Subject: MHI's Responses to US-APWR DCD RAI No.641-5045 Revision 1 (SRP 19)

**Responses to Request for Additional Information No.641-5045
Revision 1**

US-APWR Design Certification

RAI NO.: NO. 641-5045 REVISION 1
SRP SECTION: 19 – Probabilistic Risk Assessment and Severe Accident Evaluation
APPLICATION SECTION: 19.1.5.2
DATE OF RAI ISSUE: 09/27/2010

Figure 1 MCR Event Tree

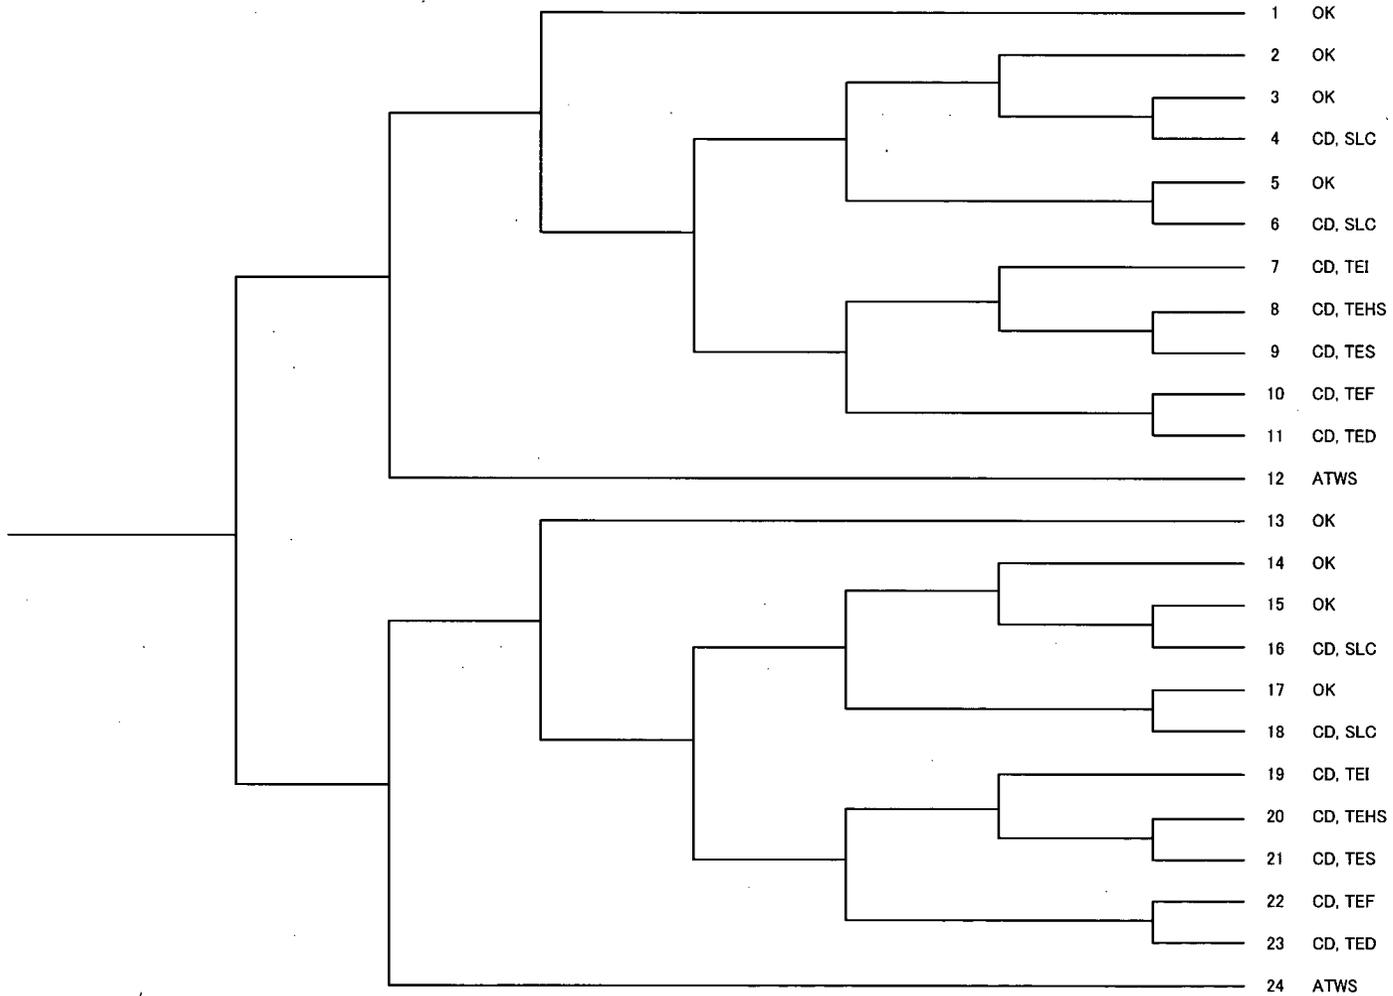
For the fire event trees currently reported in Chapter 23 and Appendix 23H of the USAPWR PRA, the staff review notes that there is no description of the event tree top events and that the success criteria for each top event are not stated in the fire PRA. Please provide this information and revise the fire PRA accordingly (e.g., a table could be added that includes a description and the success criteria for each top event identifier).

Moreover, because it is assumed that any fire in the MCR will not damage the mitigation function, the MCR ET has been developed based on the TRANS ET of the internal events PRA, but EVA has been added as the top event of the MCR event tree. The MCR ET is shown in Figure 1.

The success criteria of the MCR ET are equivalent to those for the TRANS ET.
